Application to Modify Development Consent Notice of Determination

Development Application No: DA/2210/2022/A
Property Address: Lot 84 DP 19828,
50 Baker Street, DORA CREEK NSW 2264
Original Proposal: Alterations and Additions - Dwelling House, Attached
Garage and Carport
Modification sought: Change from Garage to Carport
Determination Status: Amended Approval
Determination Date: 5 January 2023
Consent to operate from: 25 October 2022
Consent to lapse on: 25 October 2027

Project
Proposed Addition,
Garage & Carport

THIS SHEET - 3

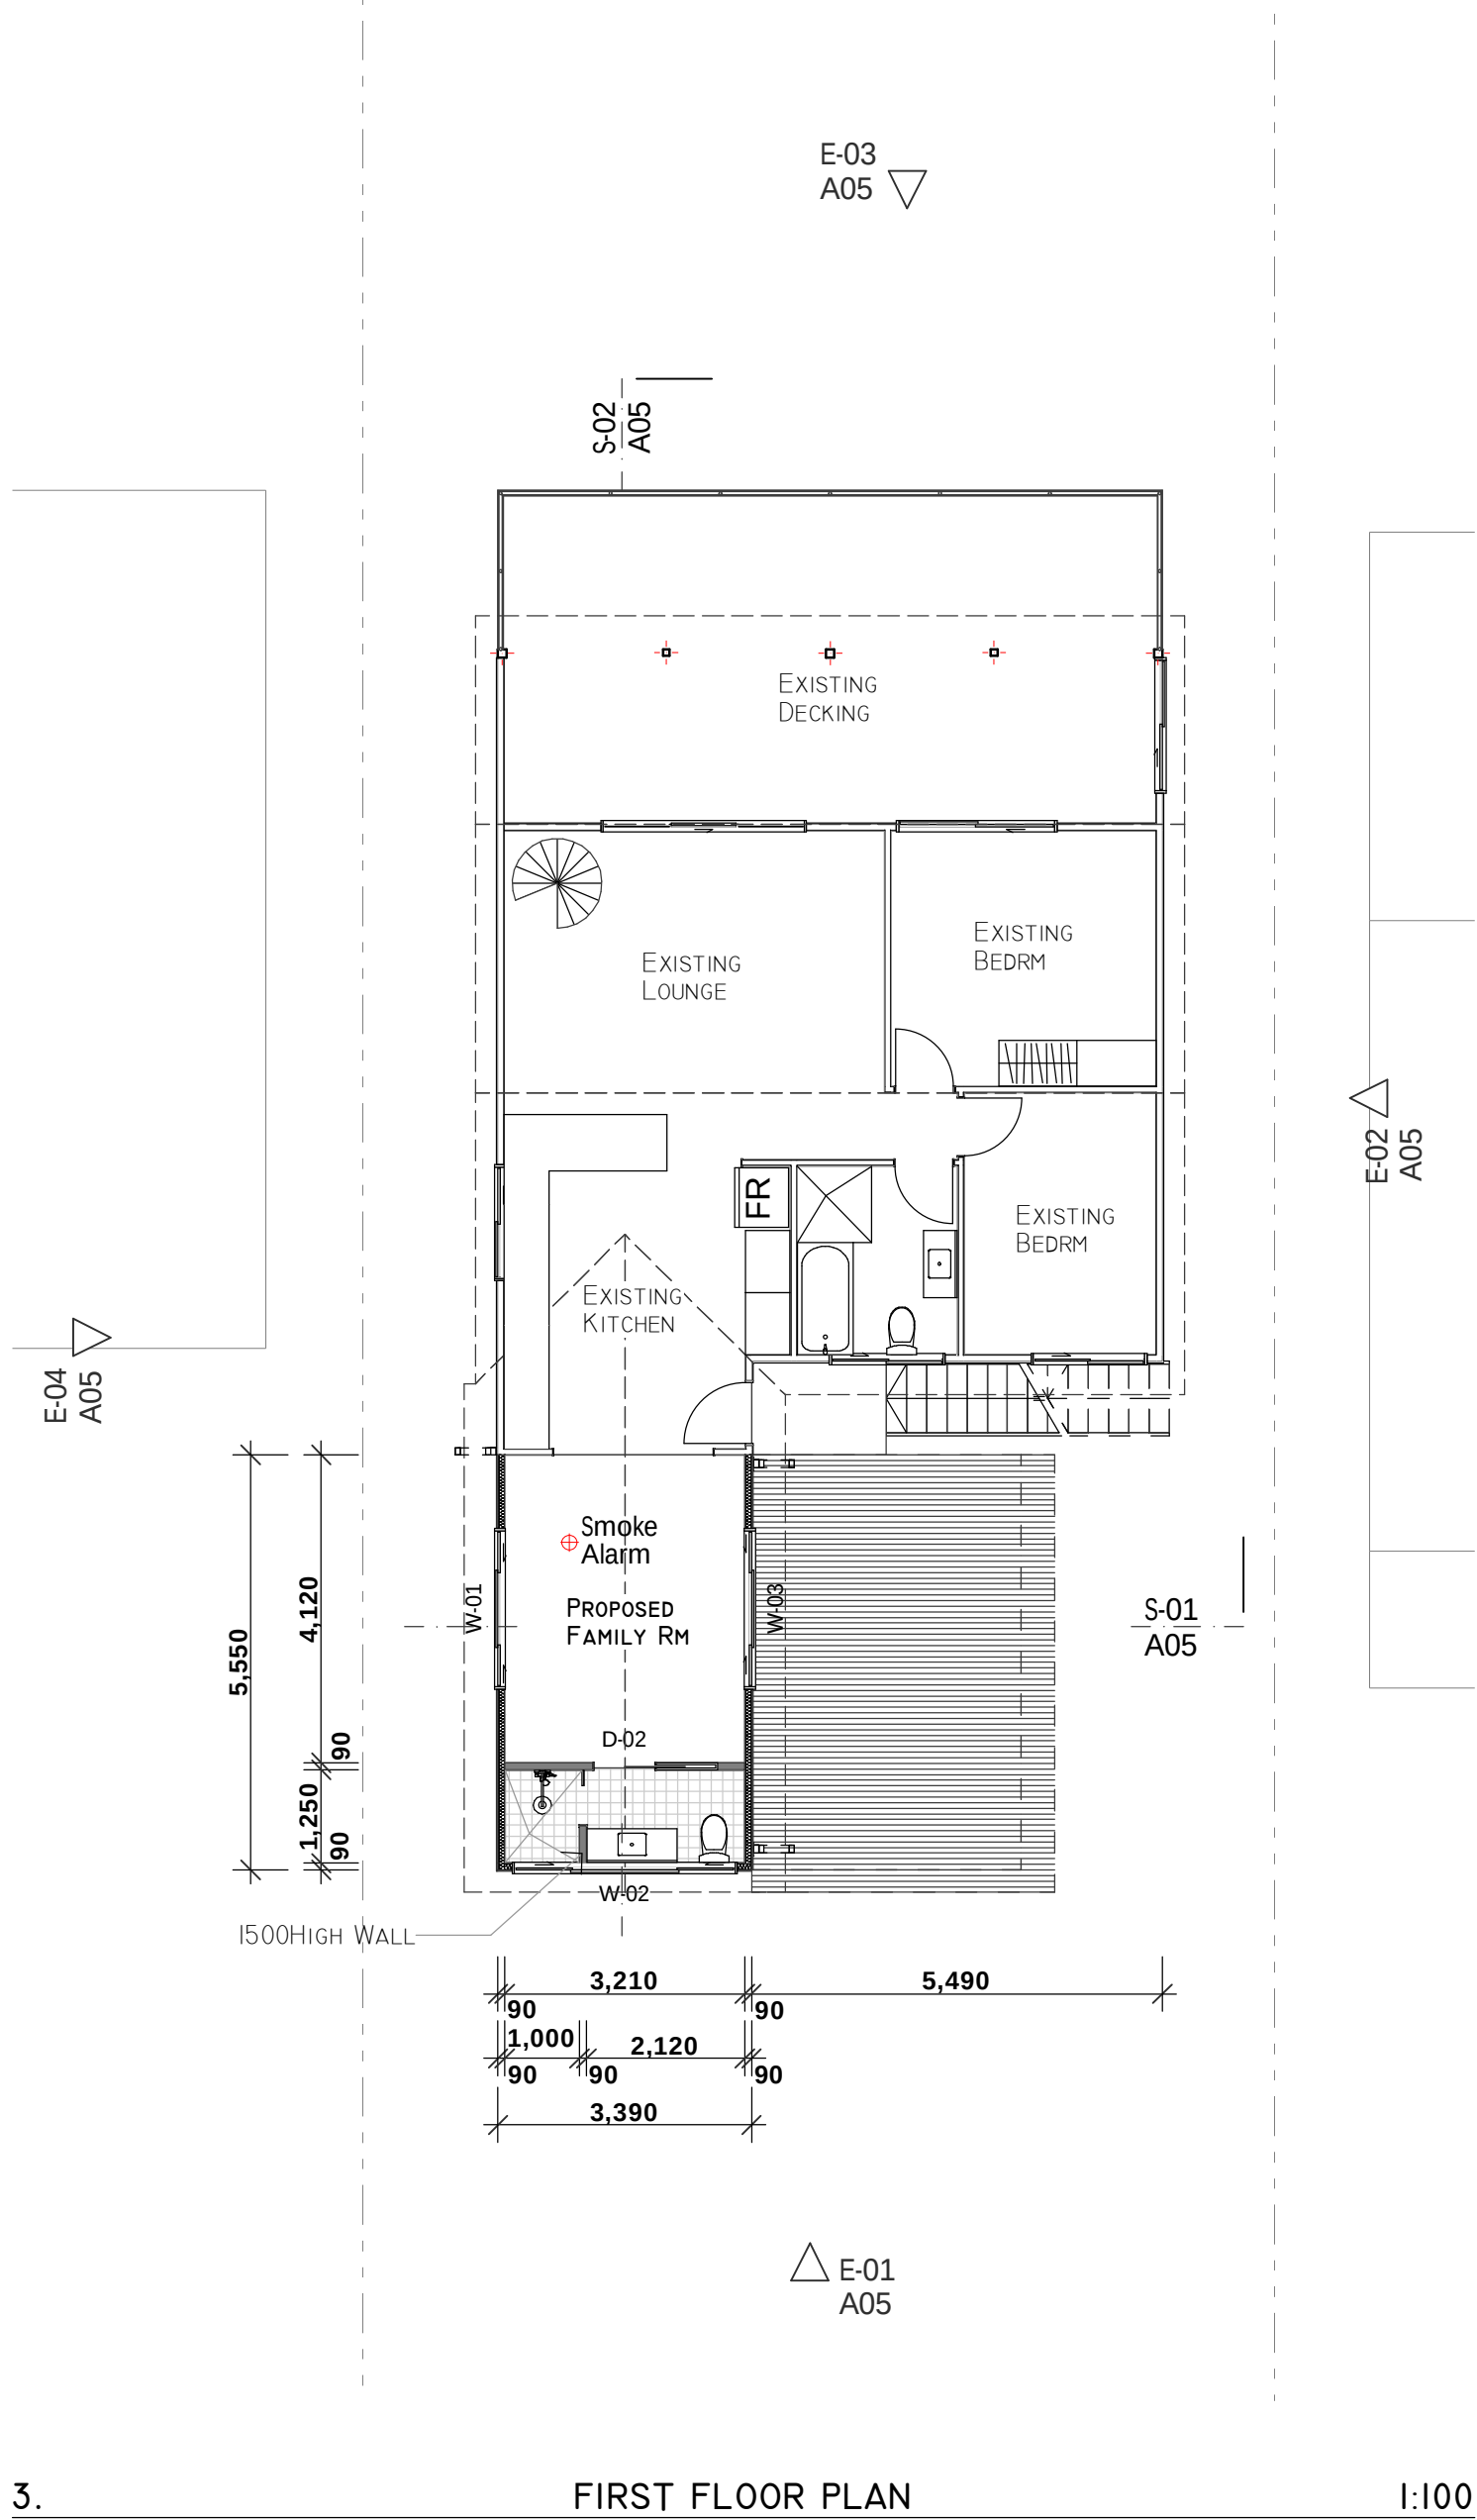
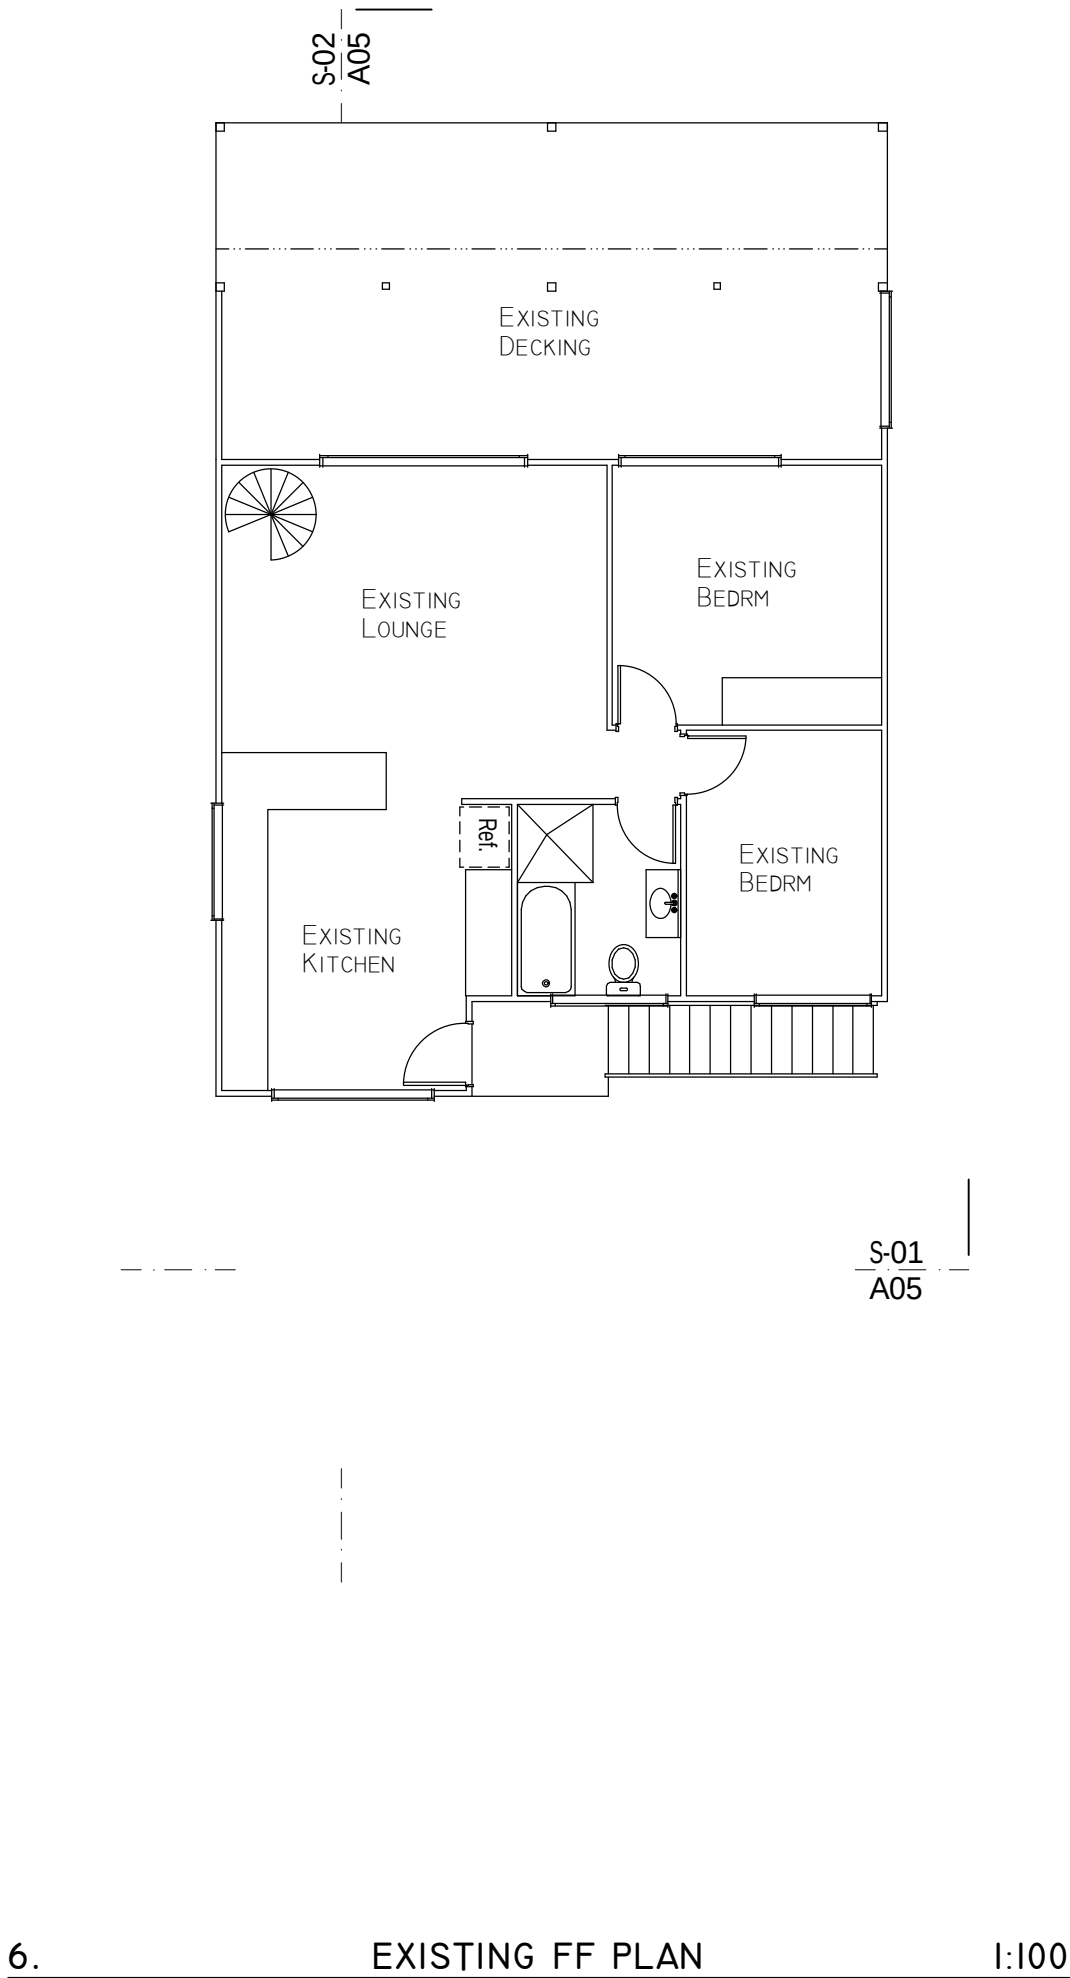
25/11/22 - SECTION 4.55
APPLICATION TO DELETE ENCLOSING
WALLS TO ALTER GARAGE TO
BECOME OPEN CARPORT & TO ALTERED
THE APPROVED GARAGE FLOOR LEVEL.

20/12/22 - DELETE GARAGE
ROLLER DOOR.

THIS SHEET - **5**
**ELEVATIONS &
SECTIONS**

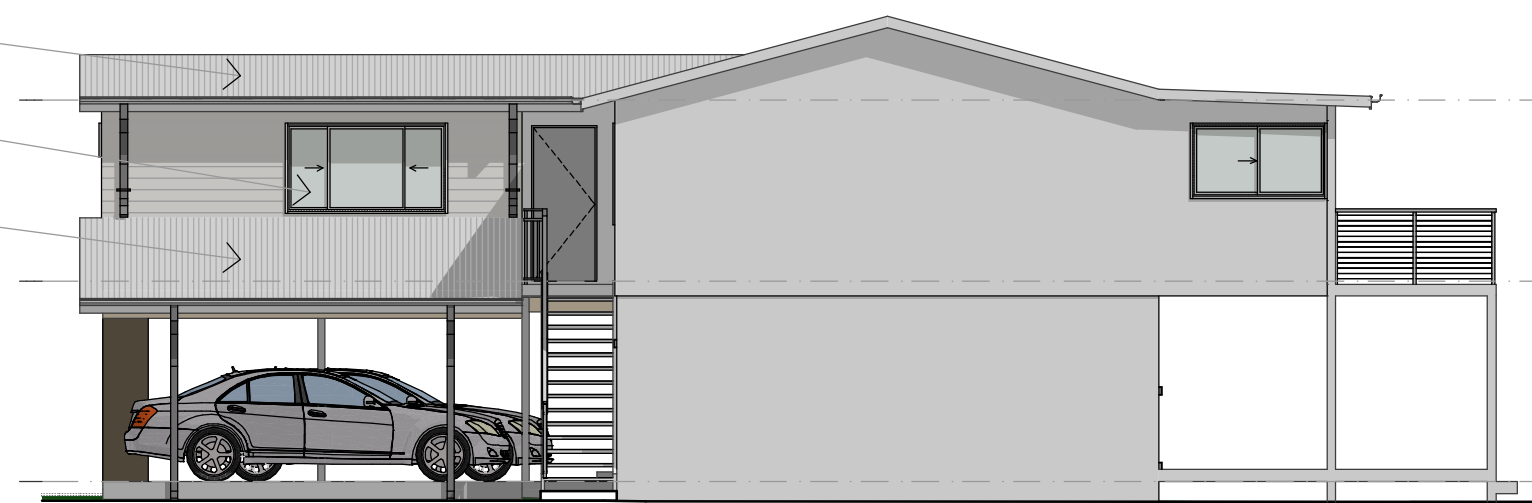
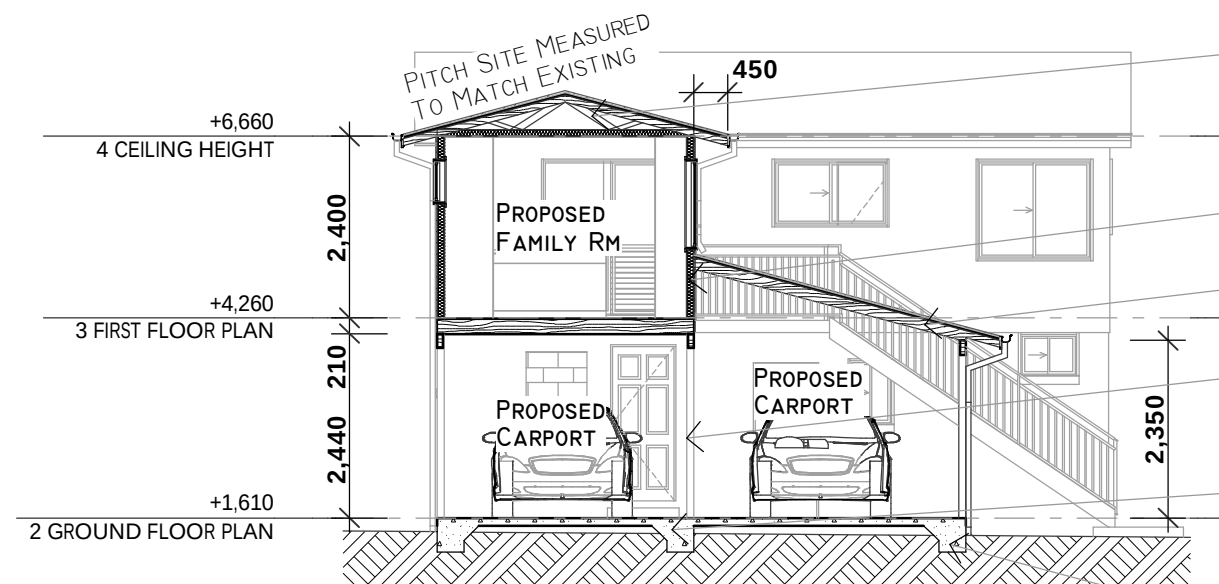
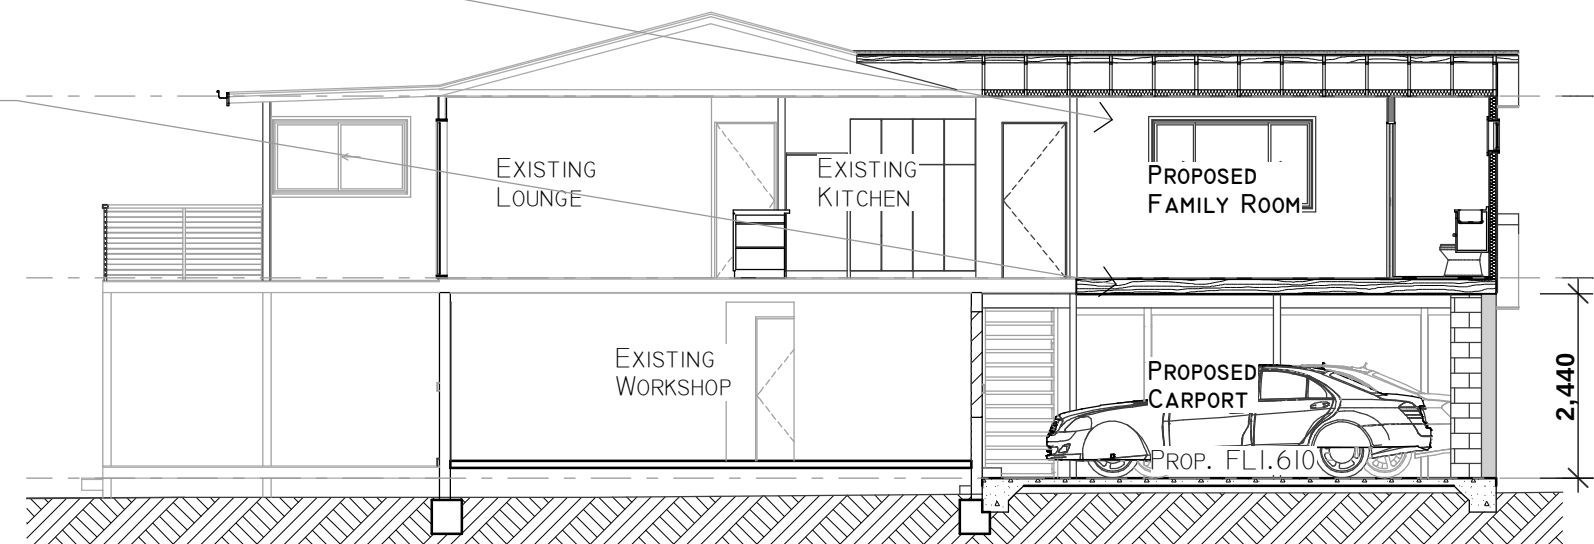
- PROVIDE SELECTED CLADDING WITH PAINT FINISH IN MATCHING COLOUR
- PROVIDE RENDERED MASONRY WALLS WITH PAINT FINISH IN MATCHING COLOUR
- PROVIDE POSTS WITH OPEN SIDES TO CARPORT, REMOVE ENCLOSING WALLS

CARPORT FLOORS TO BE AT RLI.610AHD TO ALLOW ROOM ABOVE TO BE AT FLOOR LEVEL THAT MATCHES EXISTING

25/11/22 - SECTION 4.55 APPLICATION TO DELETE ENCLOSING WALLS TO ALTER GARAGE TO BECOME OPEN CARPORT & TO ALTERED THE APPROVED GARAGE FLOOR LEVEL.

20/12/22 - DELETE GARAGE ROLLER DOOR.
